SERVICE LETTER NUMBER 12			
TITLE: WATER RUDDER REPAIR			
BY: E. BISHOP	AIRCRAFT MAKE/MODEL(S): N/A	FLOAT MODEL(S): 8000, 8750, 10000, 7000 FLOATS WITH SERVICE LETTER 135, 6000/6100 FLOATS WITH SERVICE LETTER 132	NOTE(S): OPTIONAL COMPLIANCE S/L P/N 1002391 ECO 23630
APP: C. WOKEN			
DATE: 1/2/15			
REV: B

There have been reports of rivet shear between the main blade and the 1/8" doubler supports on the water rudder. It is recommended that more rivets be added.

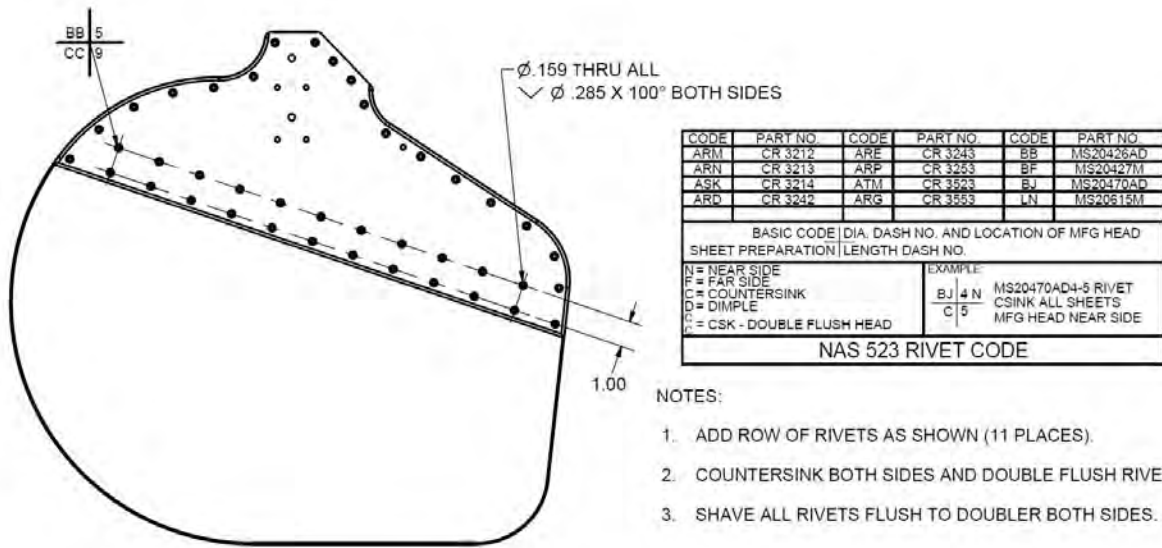
Add second row of rivets 1.00" above the lower row of rivets in accordance with the figure below.

Add rivets in accordance with the drawing included with this service letter (see Technical Data section).
